**Preliminary detailed assessment of best available techniques (BAT) for General Nuclear System Limited's UK HPR1000 design - AR03**

This report covers our Generic Design Assessment (GDA) of General Nuclear System Limited's (GNSL's) submission on best available techniques (BAT) for the United Kingdom Hualong Pressurised Water Reactor design (UK HPR1000) as required in Table 1, Items 2, 4 and 5 of our Process and Information Document (P&ID) (Environment Agency, 2016).

**Figure 3: Liquid effluent streams and LRWMS (GNSL, 2020b)**

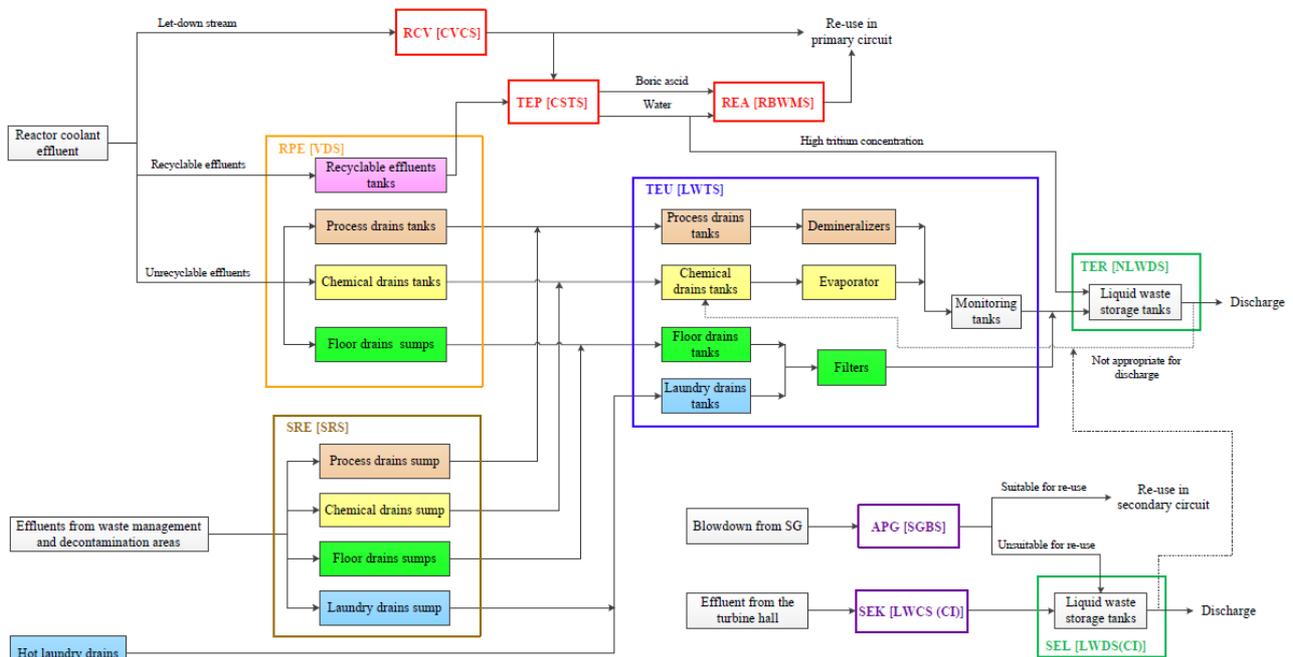
The techniques in the LRWMS include using filters, demineralisers and evaporators as shown in Figure 3 in section 2.8. The filters remove insoluble solid particles and fibres, the demineralisers remove soluble radionuclides, and the evaporators extract distillate and keep impurities in the concentrate. The demineralisers contain ion exchange resin and the regulators queried the validity of expected decontamination factors (DFs) and how the DFs are optimised (RQ-UKHPR1000-0725). The response to the RQ confirmed that the expected DFs are determined from OPEX and demonstrated that the abatement efficiency is optimised by considering factors, including resin volume, equipment design parameters and other measures to maximise the efficiency (such as monitoring and sampling, and pH and impurity control). A future operator will need to demonstrate that the selection of resin and resin change strategy used in demineralisers is optimised and can be demonstrated to be BAT. We have raised an Assessment Finding to this effect.

**Assessment Finding 5: A future operator shall demonstrate that the UK HPR1000 will be operated in a way that represents best available techniques for the selection and change strategy of demineraliser resins for liquid waste management systems.**
